Port Credit West Village

Street Right of Ways: Response to City Comments

2018.11.02

For City of Mississauga, by
the West Village Partners

STREET A: At Curbside Layby Condition

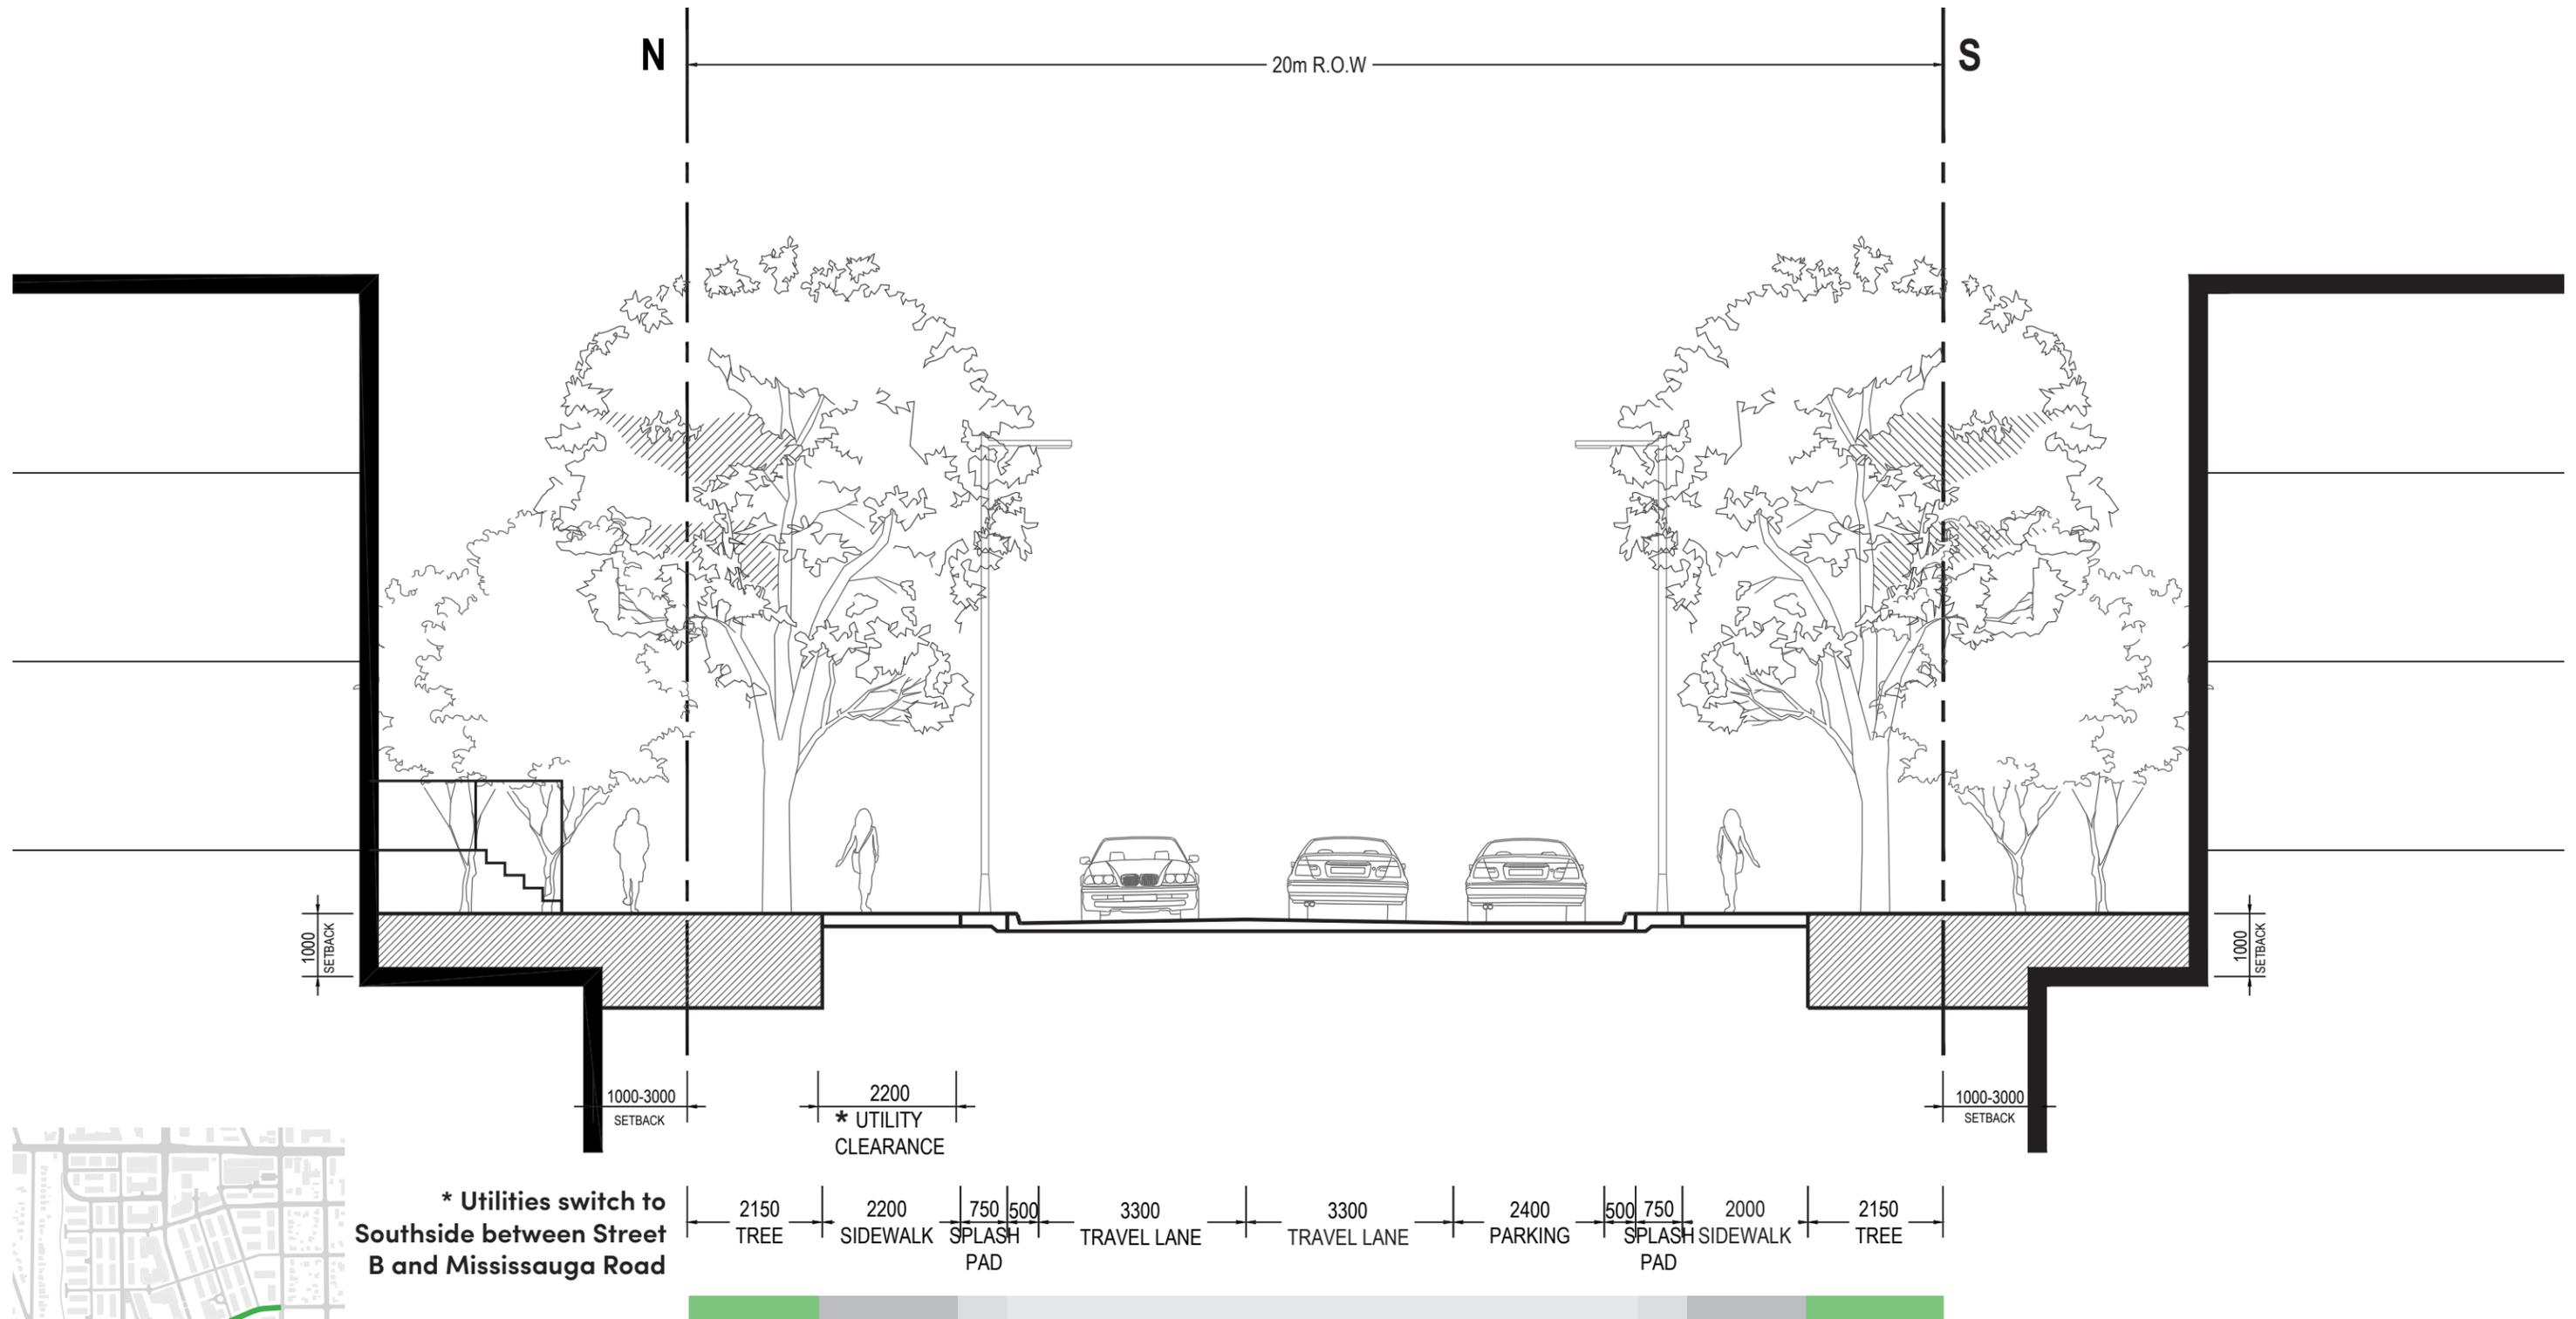
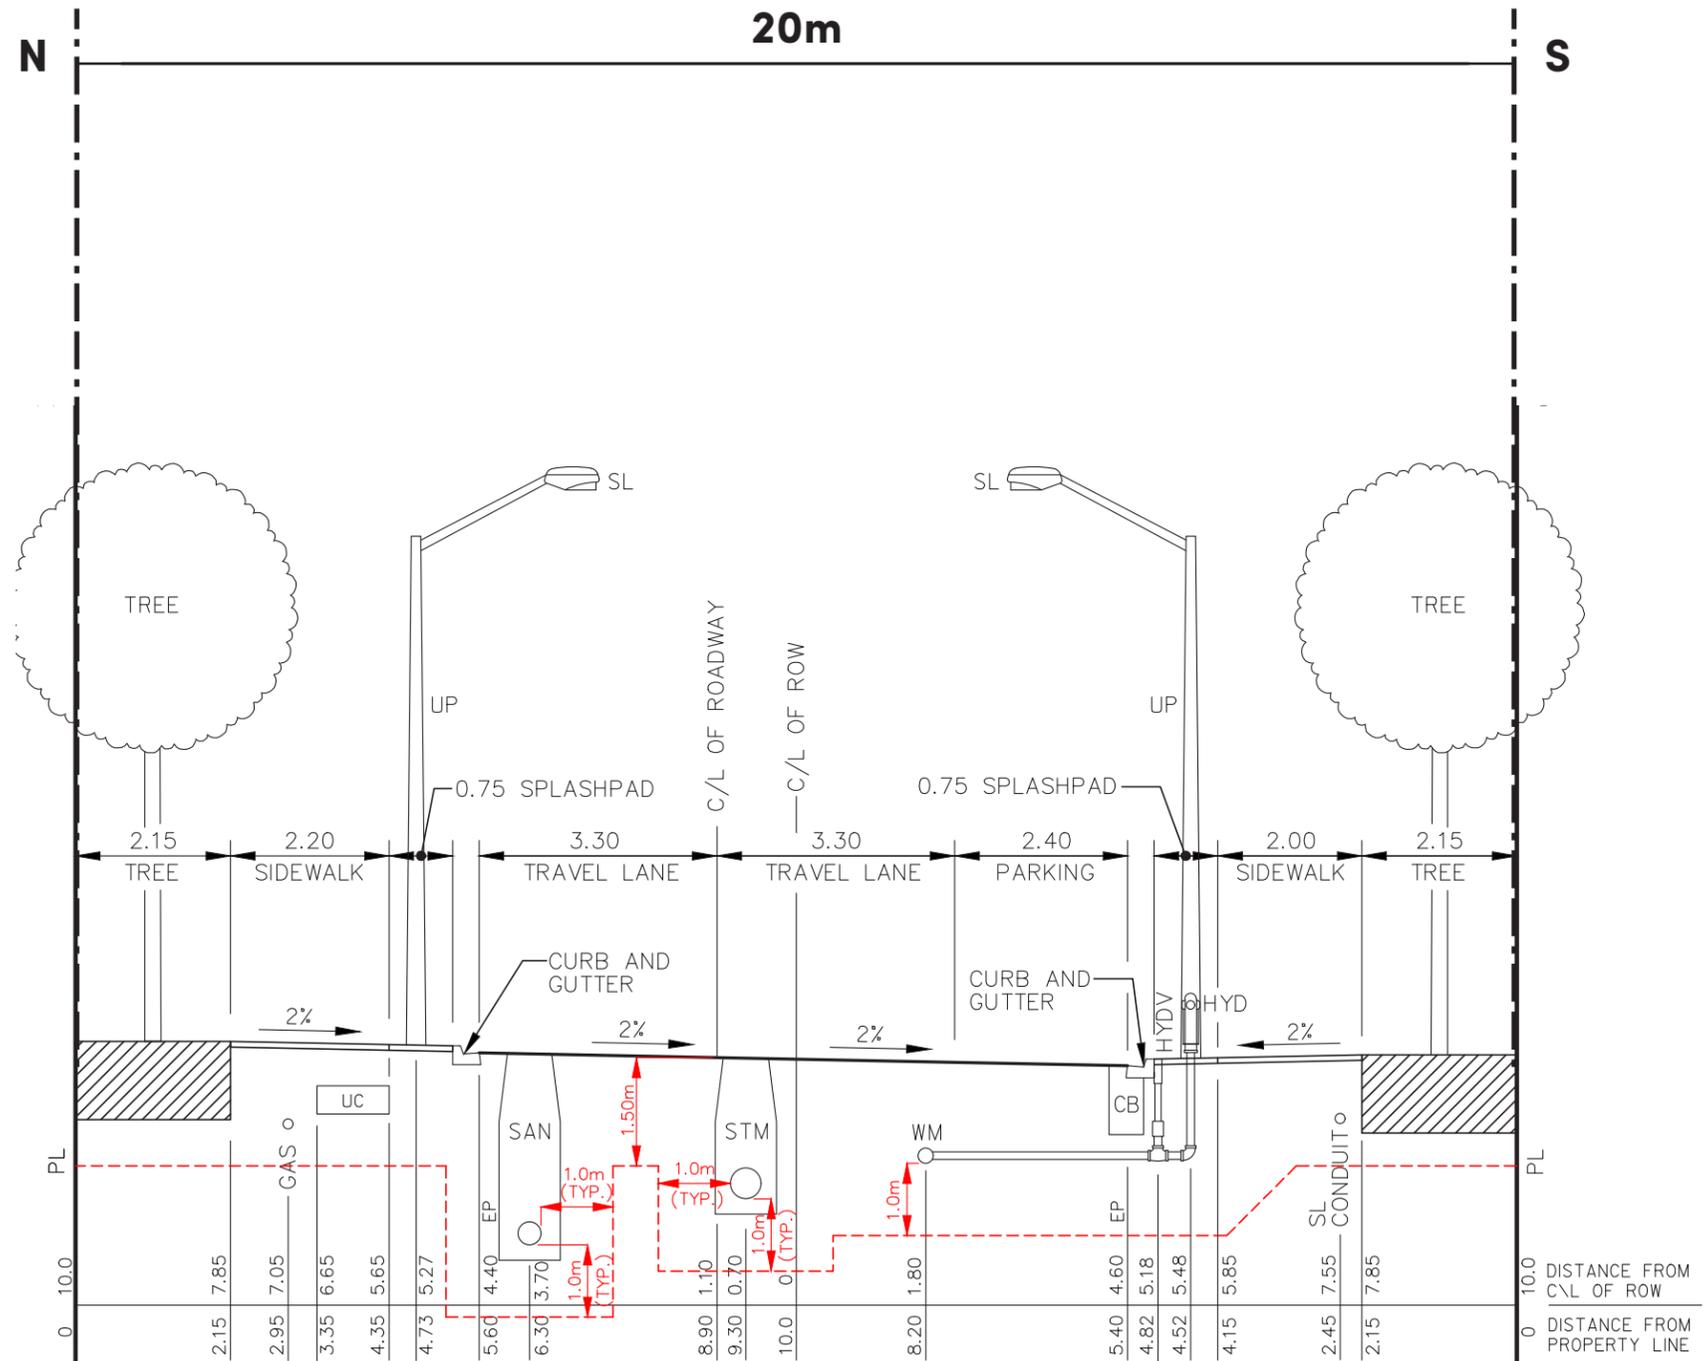
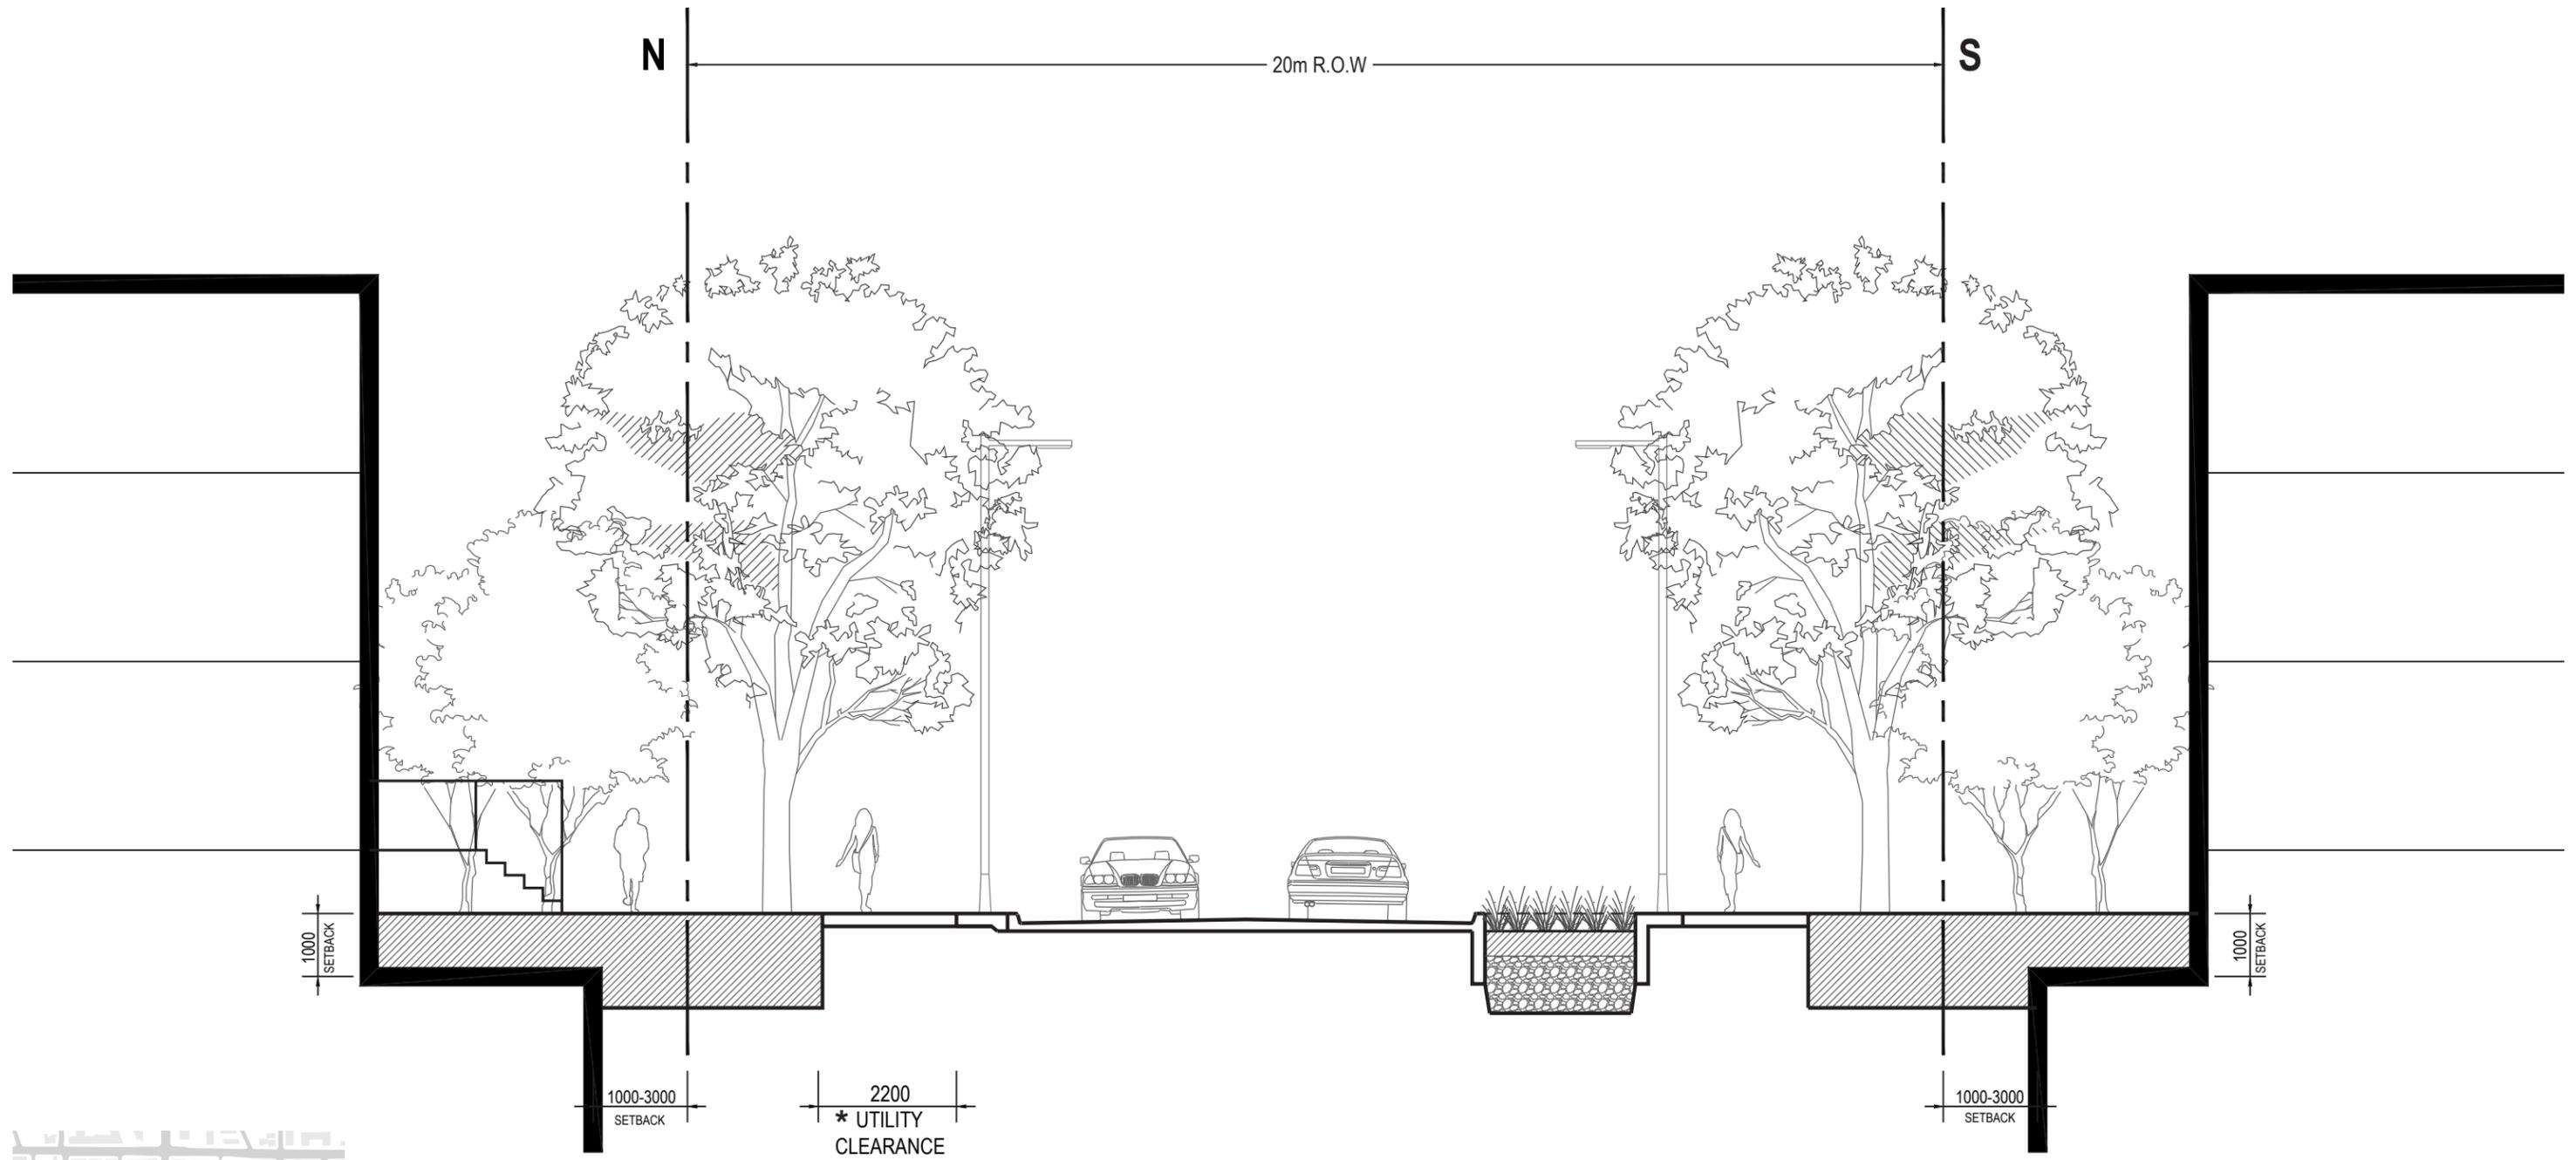
*** Utilities switch to Southside between Street B and Mississauga Road**
